***Interactive comment on “A new approach to accurate validation of remote sensing retrieval of evapotranspiration based on data fusion” by C. Sun et al.***

Received and published: 28 April 2010

Fig. 1. diagram

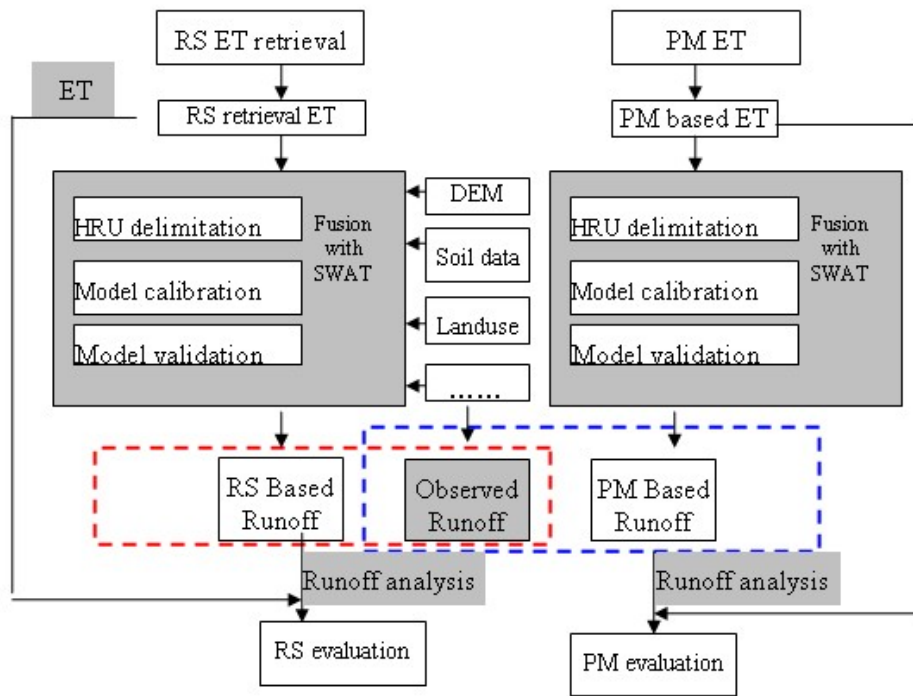
-We have modified the diagram to demonstrate our approach more clearly: 1)RS-derived ET is used as one of the input factors for SWAT, 2)RS-derived ET and other data (Digital Elevation Model (DEM), landuse data , soil data, etc) are processed together in SWAT to simulate the hydrological cycle, 3)The Runoff is output from the

SWAT, 4)The output Runoff is compared with observed runoff data, 5)The RS-derived ET is evaluated based on the results of 4).
